TECHNICAL INFORMATION

Product Name Nikon FM2/FE2/FA

Ref. No. FM2-840024

SHUTTER IMPROVEMENTS

Figure 1

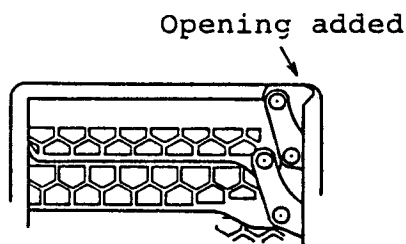
The upper wind-side corner of the inner aperture frame has been re-contoured to prevent the interference with the edge of closing curtain that travels with shaking between the aperture frames. See Figure 1.

Figure 2

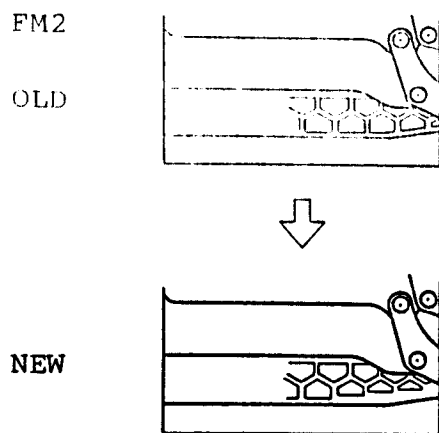
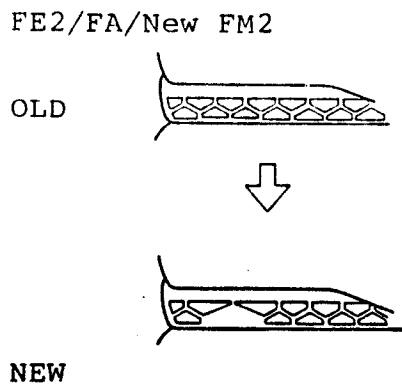
One part of the honeycomb structure has been changed to reinforce the blade of closing curtain. See Figures 2 and 3.

Figure 4

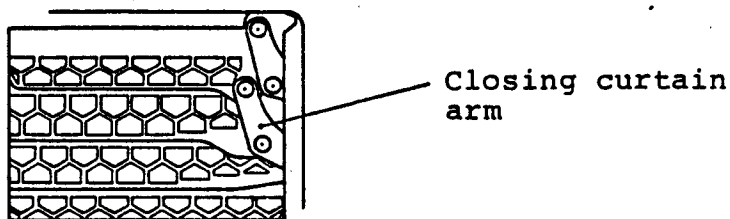
The material of closing curtain arm has been changed from titanium into carbon steel for reinforcement. See Figure 4.

Figure 5

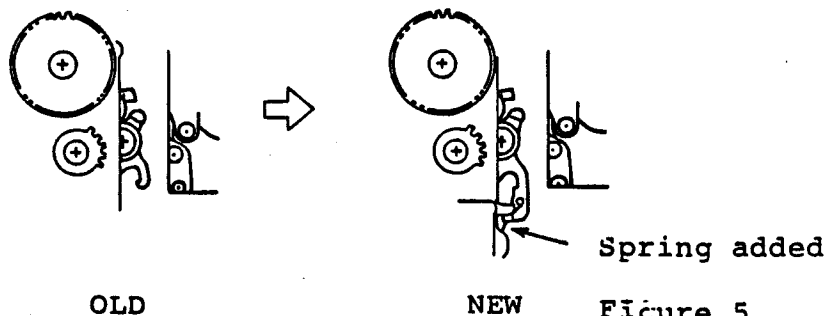
A spring has been added to the closing curtain brake to increase the efficiency of braking. But this has not been applied to the former FM2 camera. See Figure 5.

Figure 6

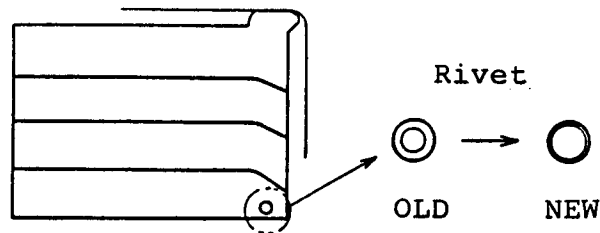
The rivets have been modified to prevent dislocation of shutter curtain blades. See Figure 6.

Figure 7.

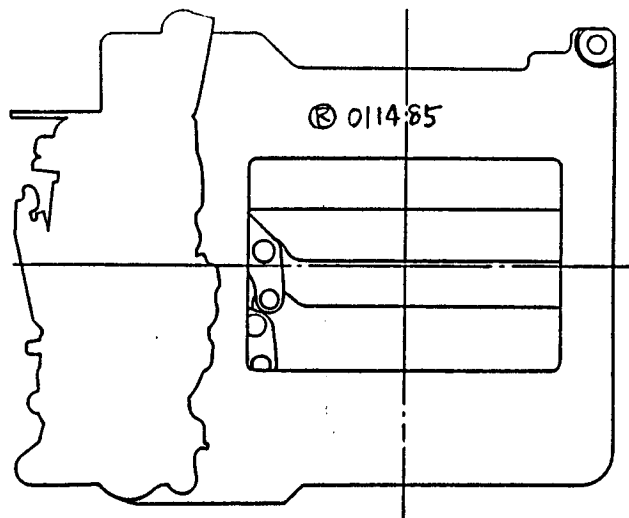
4. Use a pencil to write the mark " (R) " and the date of repair on the aperture plate. It will give a reference for future repair. See Figure 7.

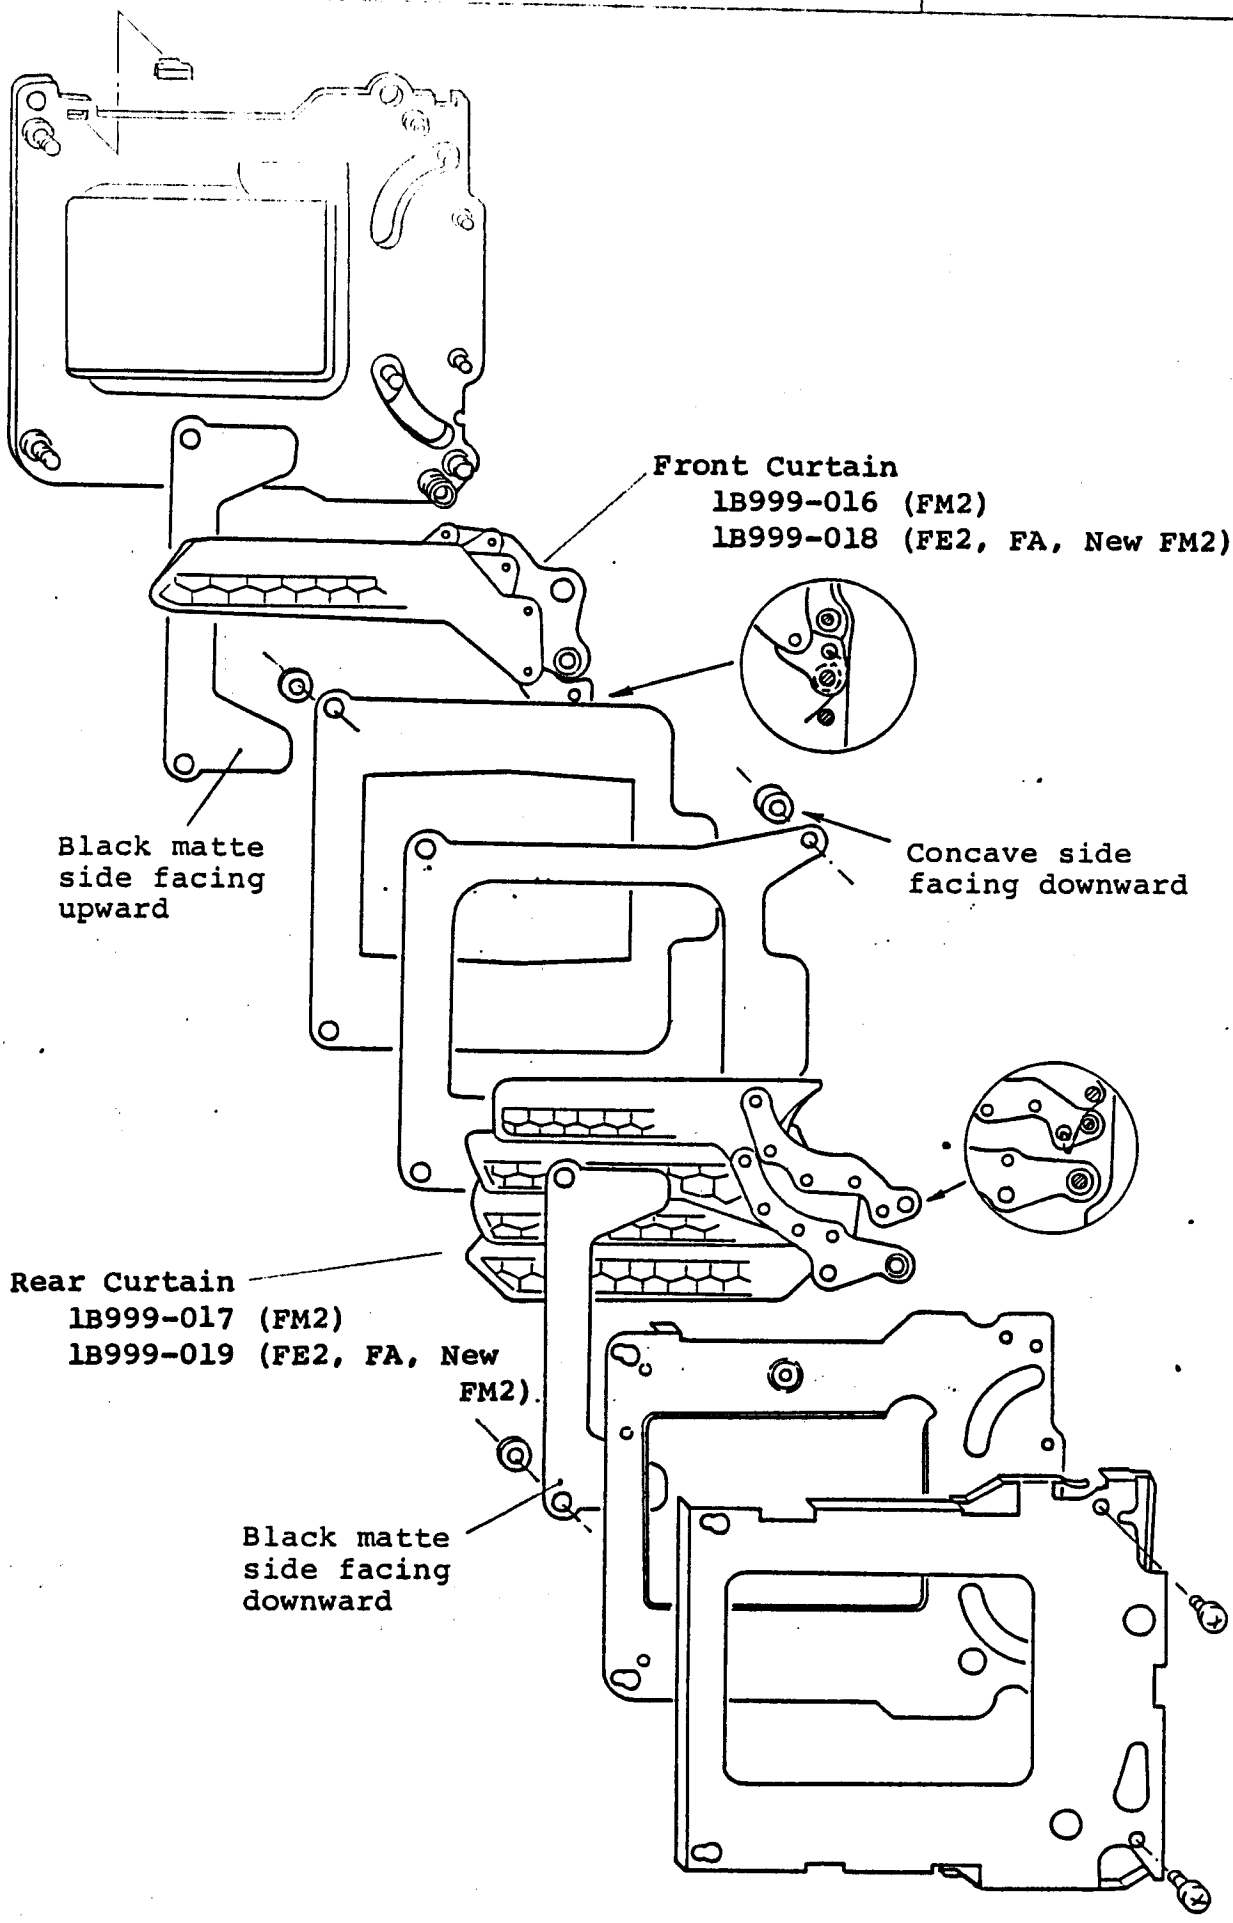
1. Check if the spare curtain blade is precisely flat, before installing.
2. See the illustration attached to disassemble/reassemble the shutter unit. The parts illustrated are of improvements. If a different pre-improved part is found in the unit of previous FM2 camera, it should be replaced in addition to the spare curtain blades. A junk shutter unit available should be disassembled to obtain the parts in need.
3. After reassembling, install the shutter unit in the camera body temporarily to check the shutter speed delivery. Set M250 when checking the FE2 and FA cameras.

Black matte
side facing
upward

Concave side
facing downward

Black matte
side facing
downward
